UNITED STATES PATENT AND TRADEMARK OFFICE

APPLICATION NO.	FILING DATE	FIRST NAMED INVENTOR	ATTORNEY DOCKET NO.	CONFIRMATION NO.
10/797,376	03/10/2004	Christoph Richter	2002P15599US	4466

Office Action Summary	Application No. 10/797,376	Applicant(s) RICHTER ET AL.	
	Examiner AARON R. EASTMAN	Art Unit 4147

DETAILED ACTION

Figures 1-6 of Allen

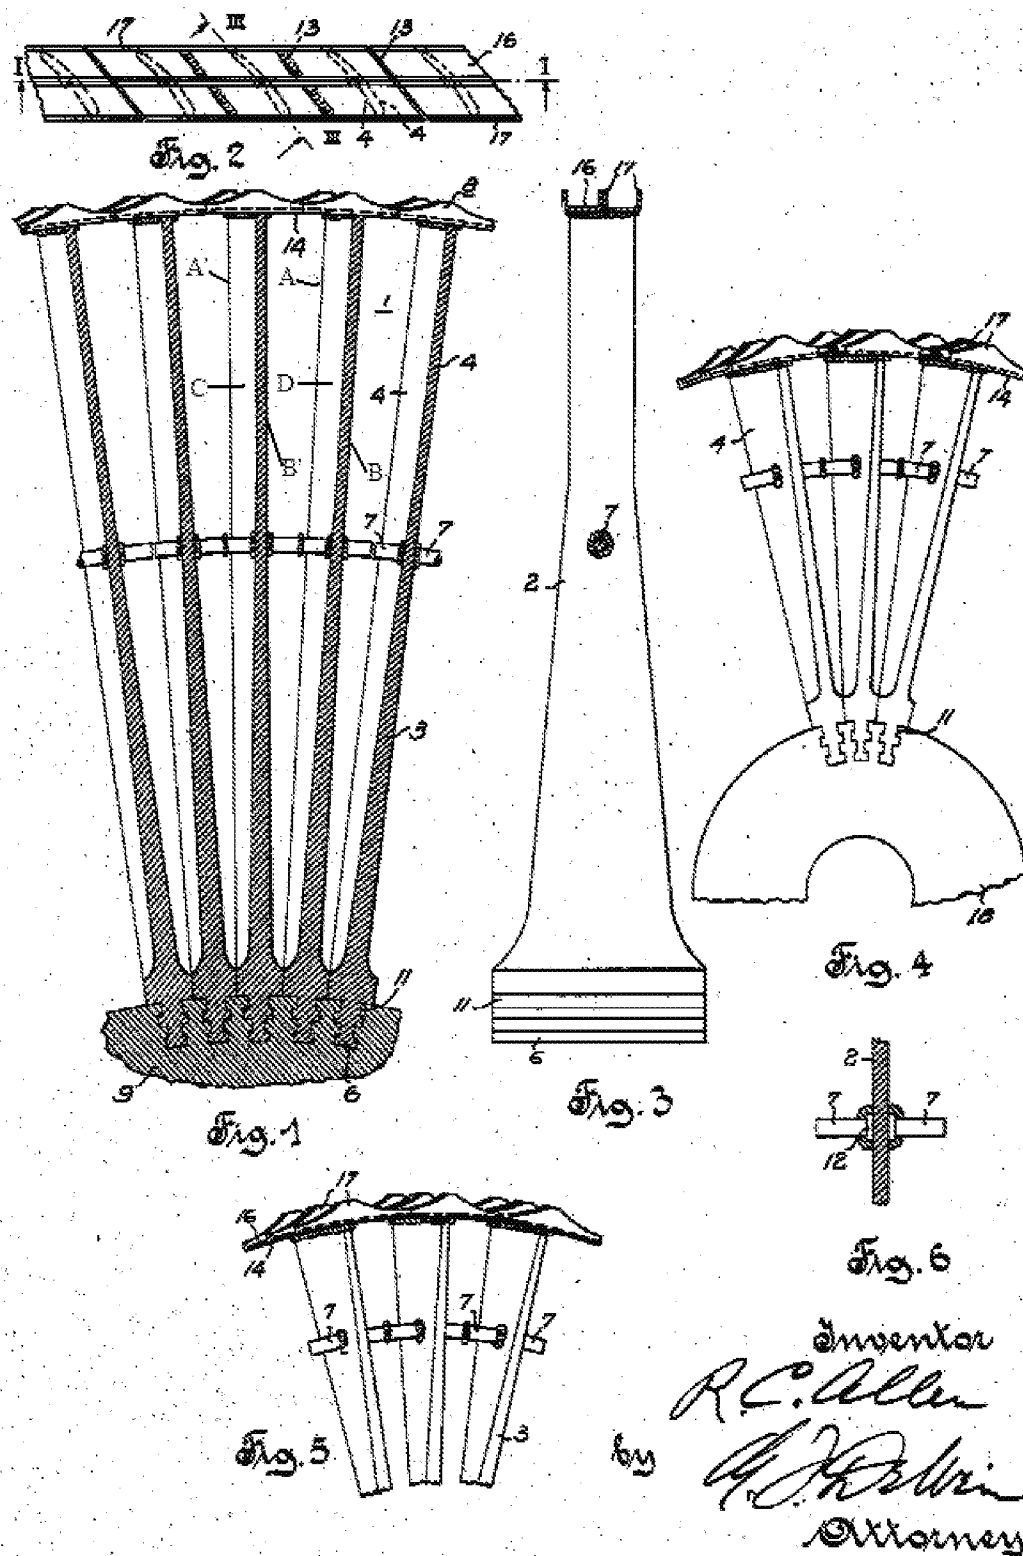
2. Claims 1, 3, 5-11, 13, 15, 16 and 18 are rejected under 35 U.S.C. 102(b) as being anticipated by US Patent Number 2,278,040 (Allen hereinafter).

3. In re claim 1, Allen discloses:

a blade (2) having a root (6), a center region, a tip, a leading edge and a trailing edge, the blades arranged circumferentially adjacent to each other to form a row;

a shroud plate (8) arranged at each blade tip, the shroud plate (8) adapted to inhibit untwisting of the blades (2); and

a support element (7) arranged between adjacent blades (2) located approximately in the blade center region and coupling the adjacent blades (2).

a first rotating blade (C) with a first leading edge (A'), a first trailing edge (B'), a first blade tip, a first blade root, a first blade center region, and a first blade shroud located near the first blade tip;

a second rotating blade (D) with a second leading edge (A), a second trailing edge (B), a second blade tip, a second blade root, a second blade center region, and a second blade shroud located near the second blade tip; and
a support element (7) located between the first rotating blade (C) and the second rotating blade (D) and arranged approximately in the blade center region, and adapted to couple the first rotating blade (C) to the second rotating blade (D).

The rotating blade as claimed in claim 6, wherein a plurality of first rotating blades (C) and second rotating blades (D) are arranged on a rotor (9) of the turbo-machine to form a row of rotating turbine blades.

The rotating blade as claimed in claim 6, wherein the first rotating blade shroud has a contact face (13) and the second rotating blade shroud has a contact face (13).

The rotating blade as claimed in claim 10, wherein blade untwist is prevented by the first rotating blade shroud contact face (13) contacting the second rotating blade contact face (13) during operation.

Figure 5 of Ortolano

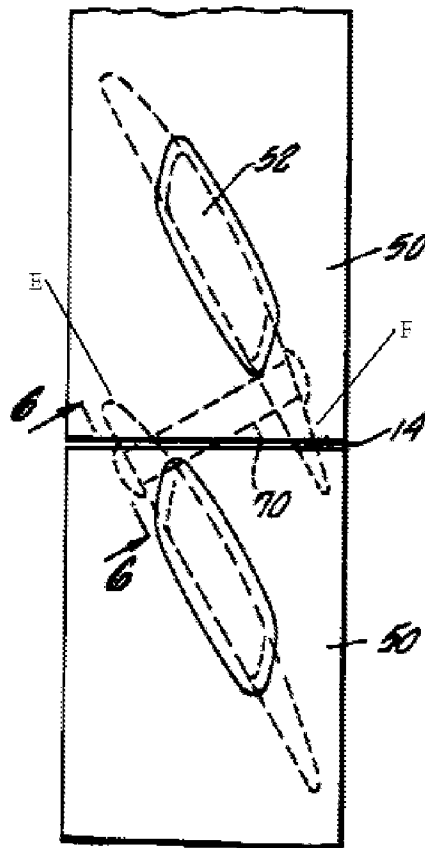
18. In re claim 2, Allen discloses all of the limitations except wherein the leading edge (E) of the blade is coupled to the trailing edge (F) of an adjacent blade by the supporting element (shown as 70 in Figure 5). However, Ortolano teaches this as seen in Figure 5 above.

19. It would have been obvious to one having ordinary skill in the art at the time the invention was made to combine the location of the supporting element taught in

Ortolano with the blade row disclosed by Allen for variations where the blade centers did not line up for convenient connection via the supporting element.

20. In re claim 12, Allen discloses all of the limitations except wherein the leading edge (E) of the first rotating blade is coupled to the trailing edge (F) of the second rotating blade by the supporting element (shown as 70 in Figure 5). However, Ortolano teaches this as seen in Figure 5 above.

21. It would have been obvious to one having ordinary skill in the art at the time the invention was made to combine the location of the supporting element taught in Ortolano with the rotating blade disclosed by Allen for variations where the blade centers did not line up for convenient connection via the supporting element.
